TECHNICAL BULLETIN

TB0056 - TCK42CRD-06 Sprocket | 2.5 YD25DDTi

Design Differences Between FAI and Original

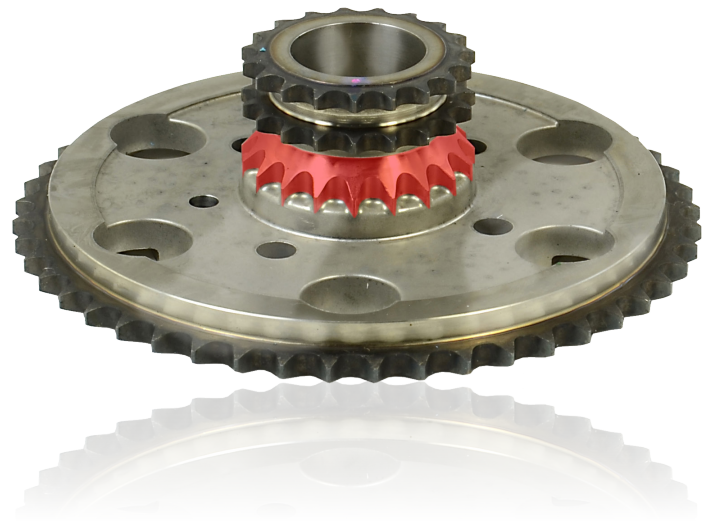
The image below shows the injection pump sprocket which has been manufactured by FAI compared with the original manufacturer design.

The sprocket supplied by FAI is a direct replacement with the only difference being the material & production methods used during manufacture.

The FAI design is strengthened by using forged steel rather than powder metal. Due to the added strength of the FAI version, the junction between the duplex and the simplex sprockets doesn't need the additional material, as indicated below.
